25 Jun 91
17th St, Outfall Canal West Bank

SUBJECT: Lake Pontchartrain, Louisiana and Vicinity Hurricane Protection Project, High Level Plan, Design Memorandum No. 20 - General Design, 17th Street Outfall Canal - 1st End Comments

SUBJECT: Lake Pontchartrain, Louisiana and Vicinity, High Level
Plan, Design Memorandum No. 20 - General Design, 17th Street
Outfall Canal

FIGURE 45
17th St. Canal Bridges
Joint Sealing Detail

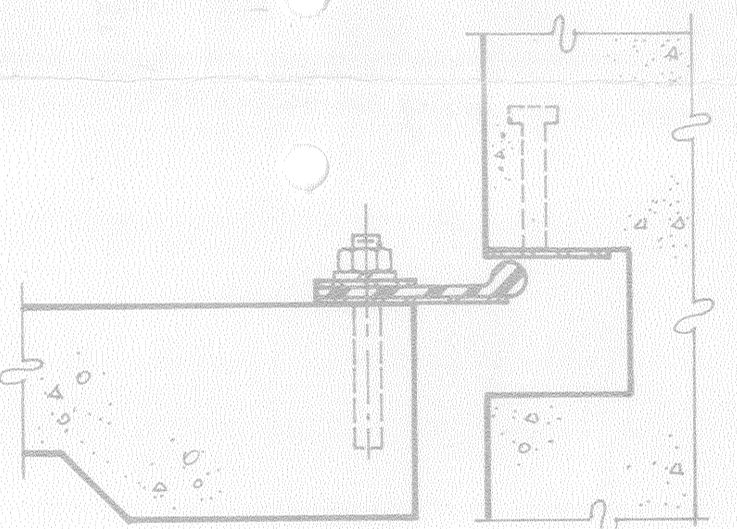
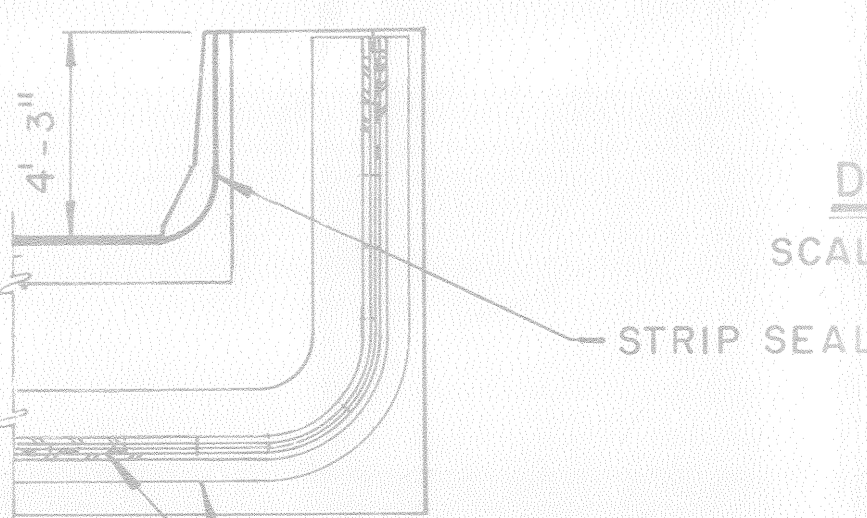
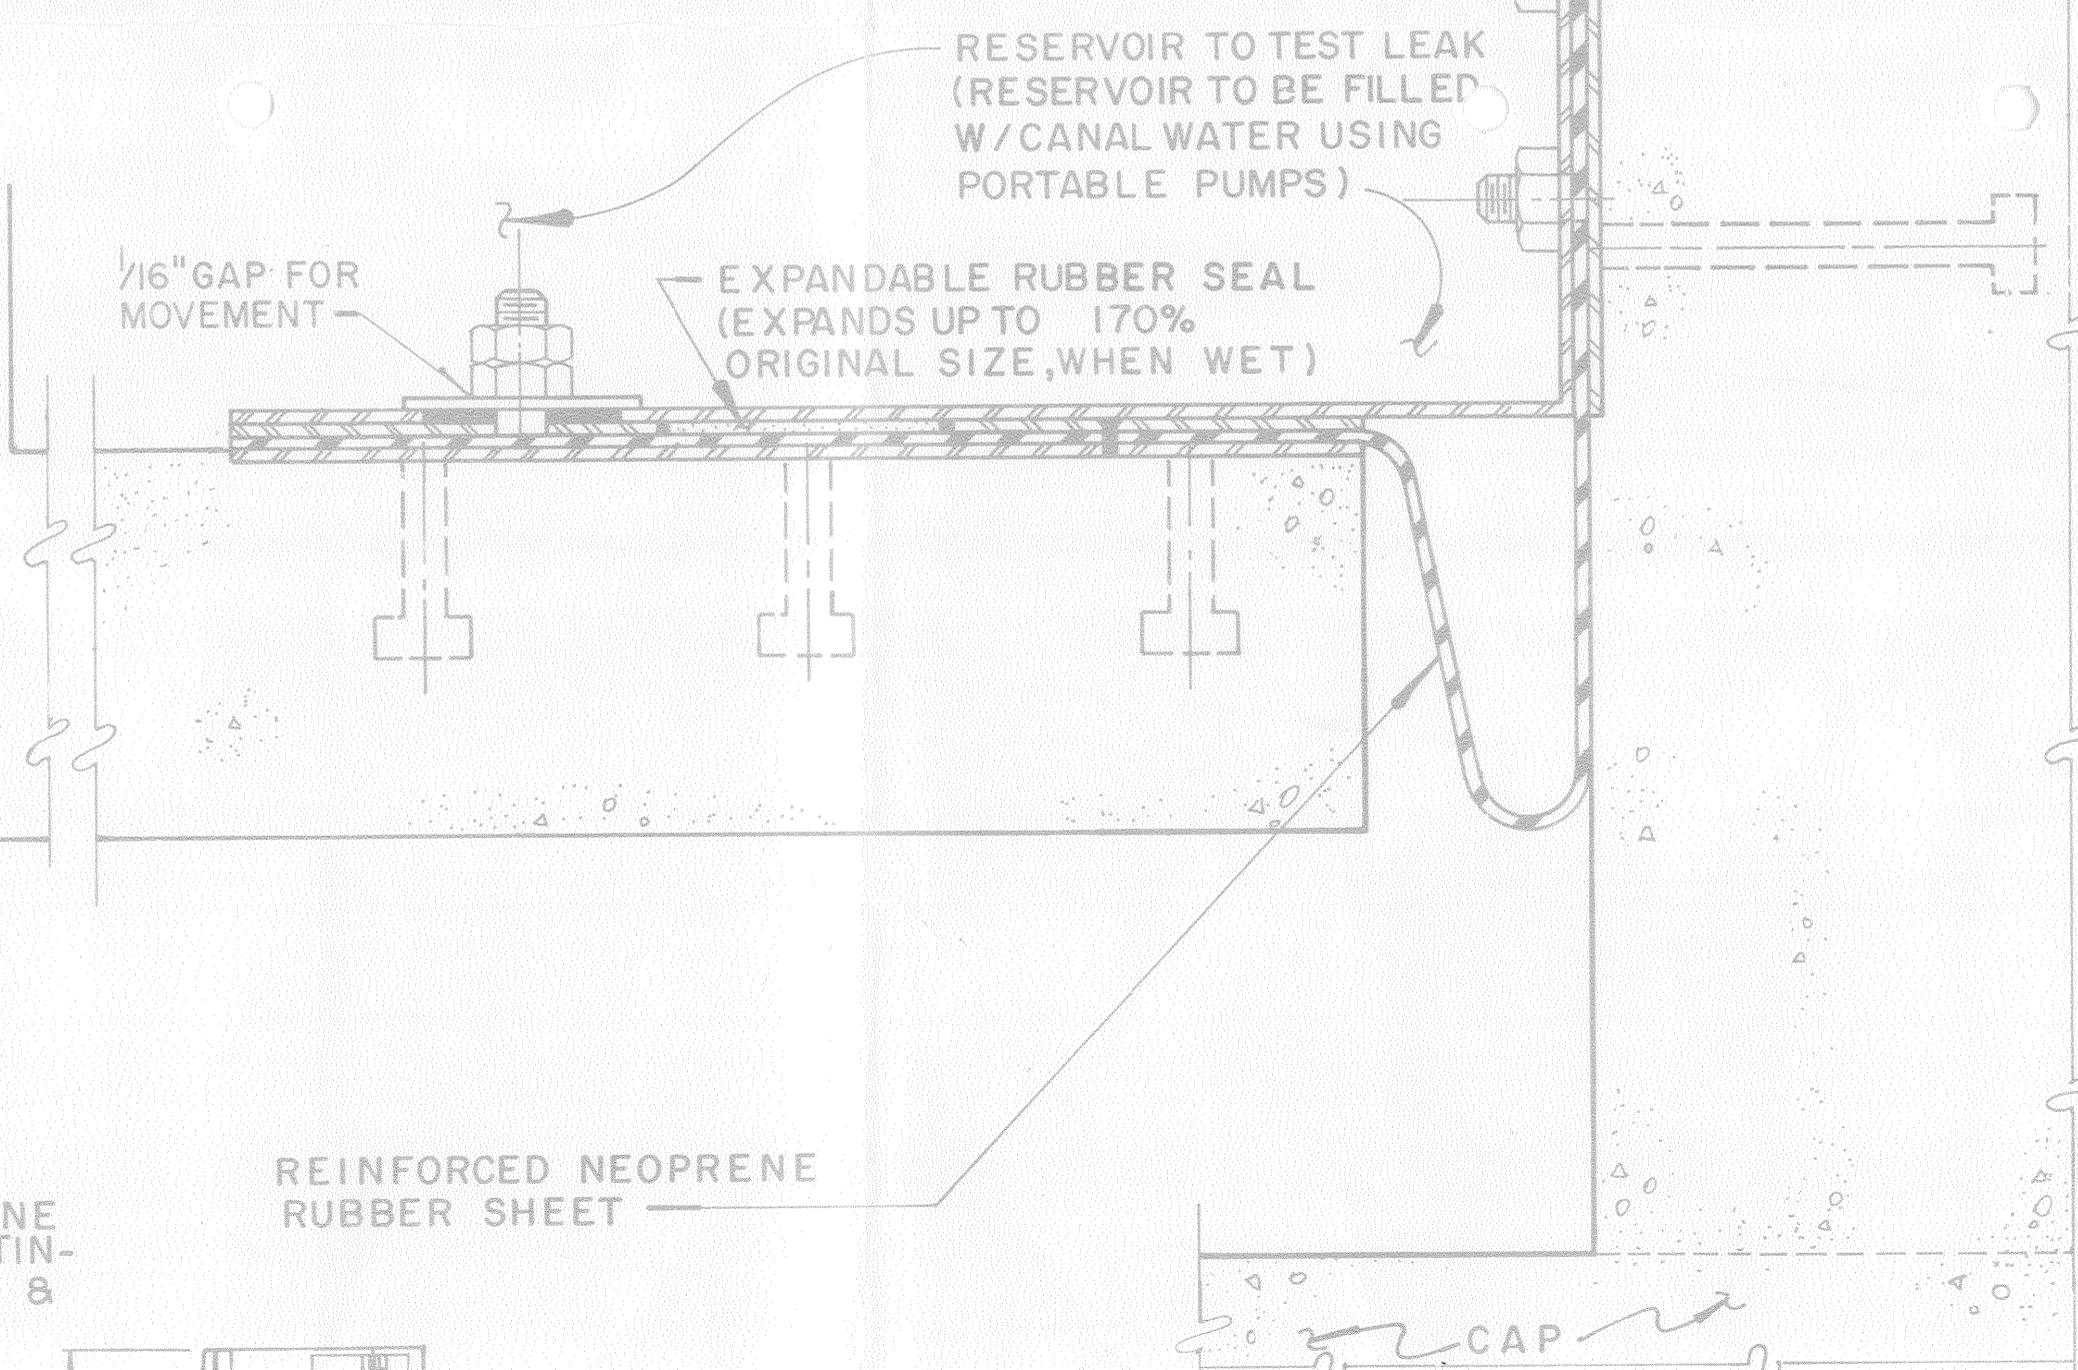
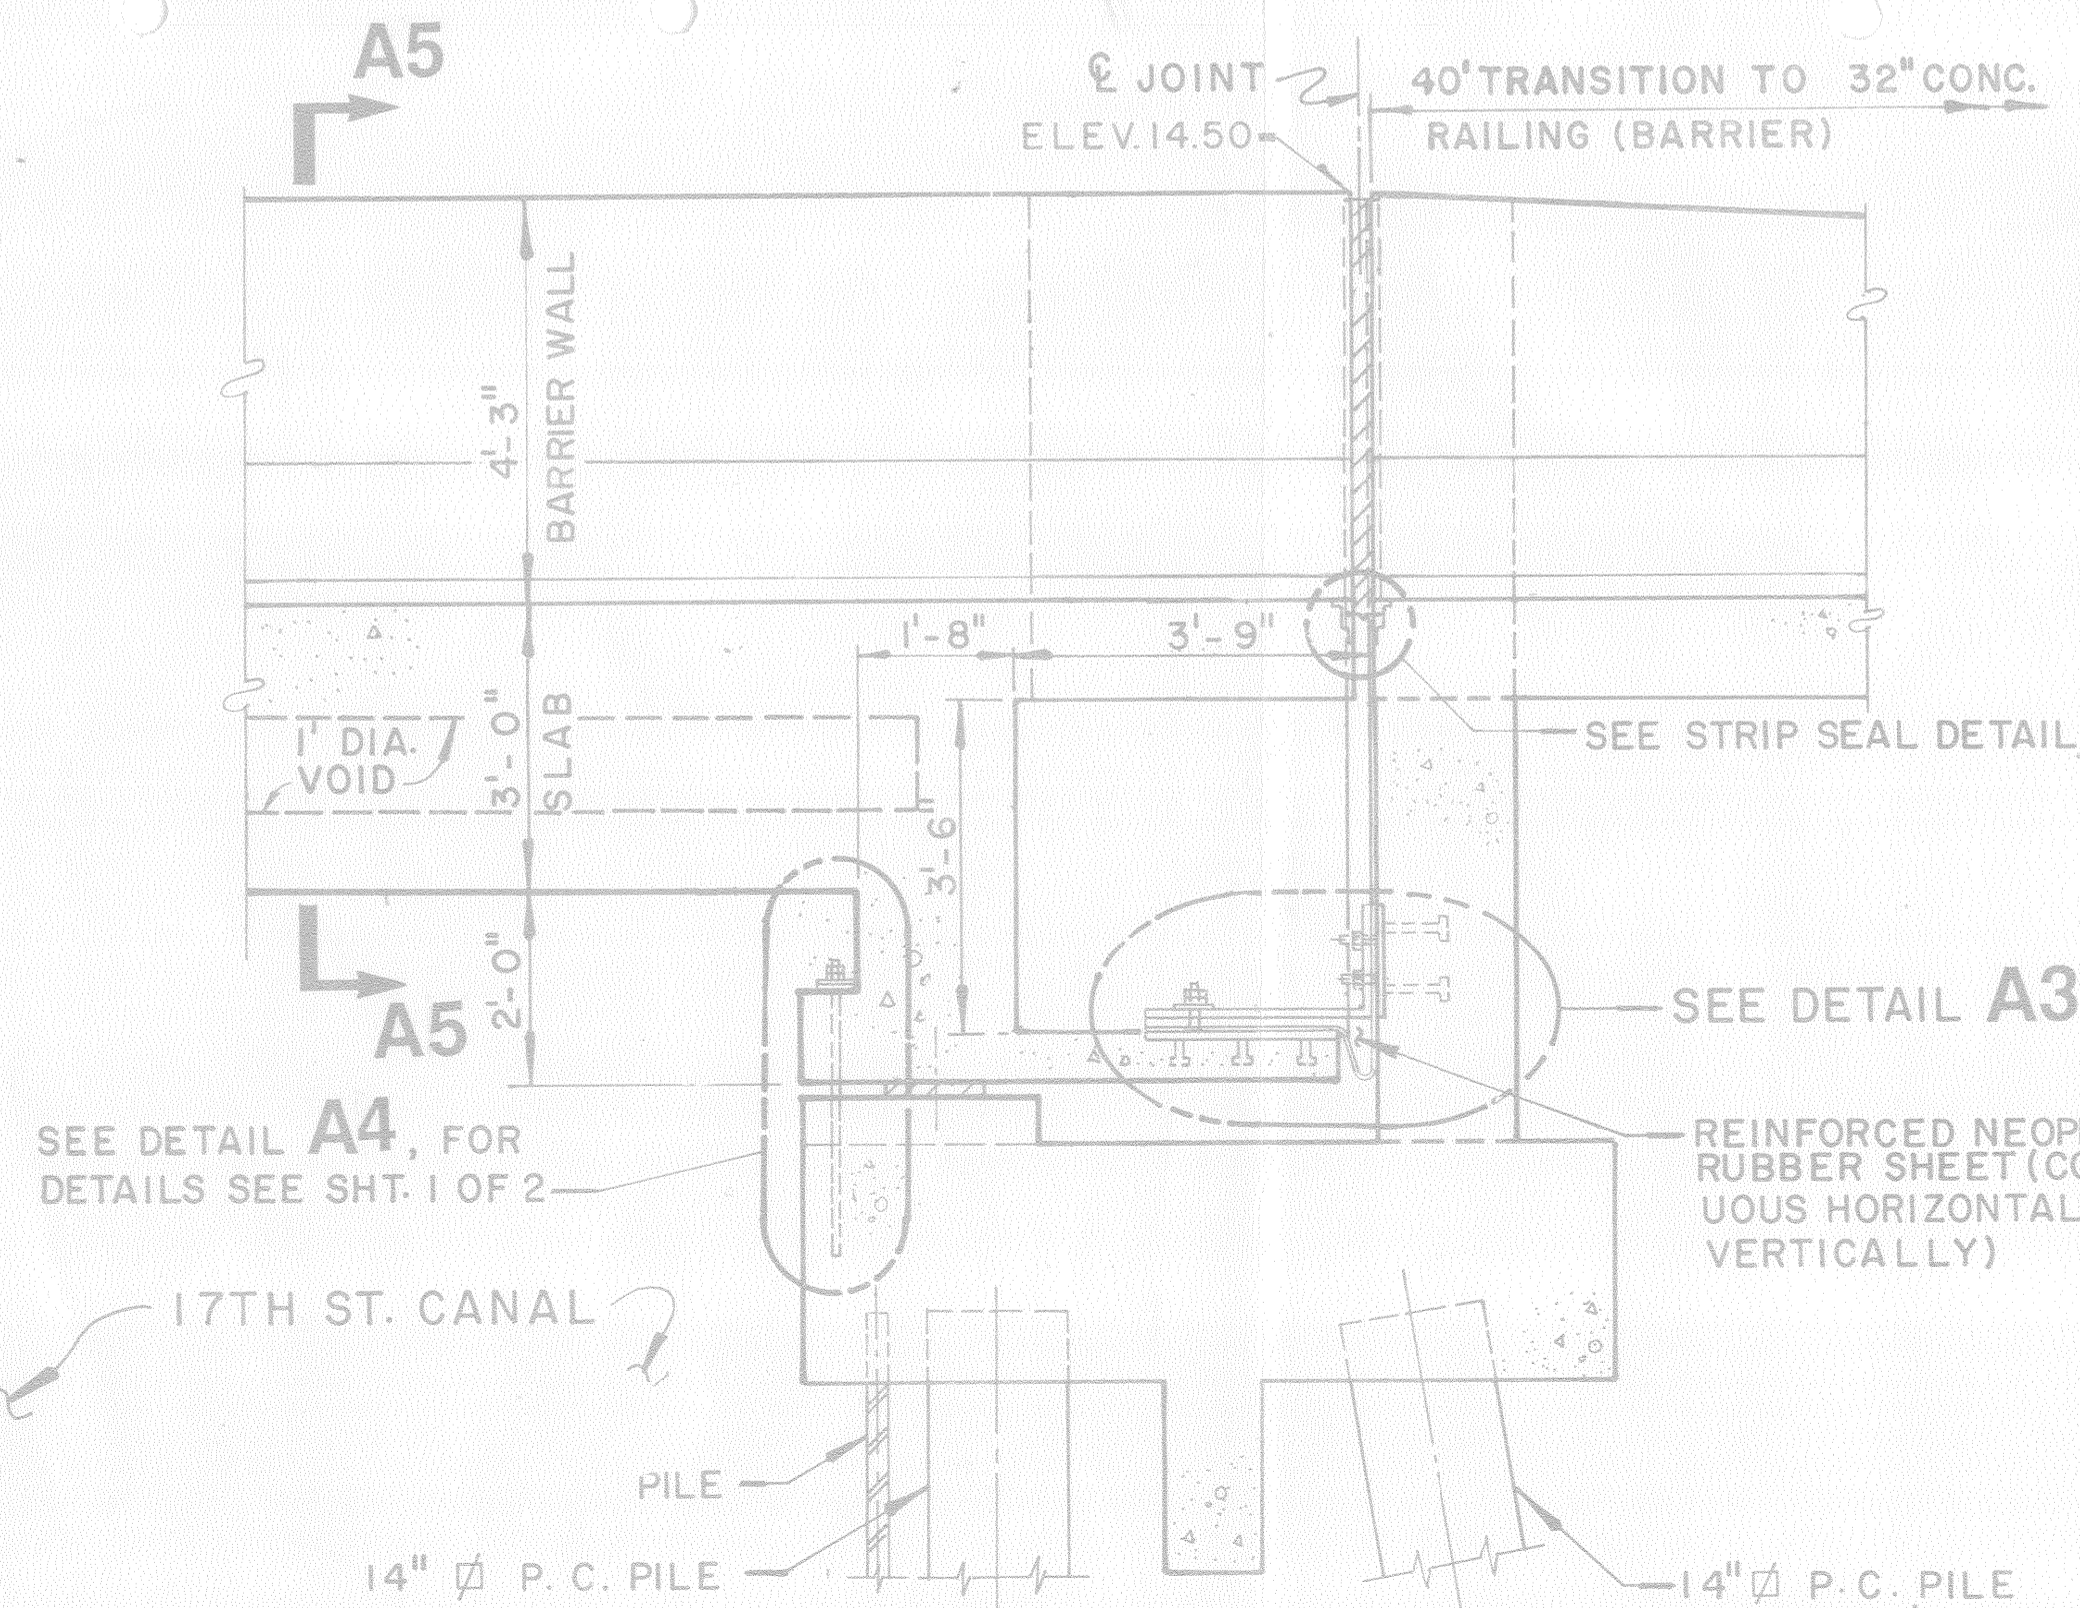
3. At the west abutment of the bridge, a seal system with multiple backups, including a reservoir, will be employed beneath the bridge to prevent water intrusion from the canal. The reservoir will provide a holding area to test for leaks in the seals. It would only be necessary to pump water into the reservoir, and monitor the water level over a period of time. Portable pumps will be required for this procedure. A periodic testing and maintenance program by LDOTD will be required to assure proper working of seals.

1. The concept of the Joint Sealing shown on the subject preliminary plans is acceptable.
2. The final submittal should include joint details with critical dimensions affecting the joint sealing material. Design computations, showing the stability of the structure under normal loading conditions as well as flood condition, must also be submitted for our review.
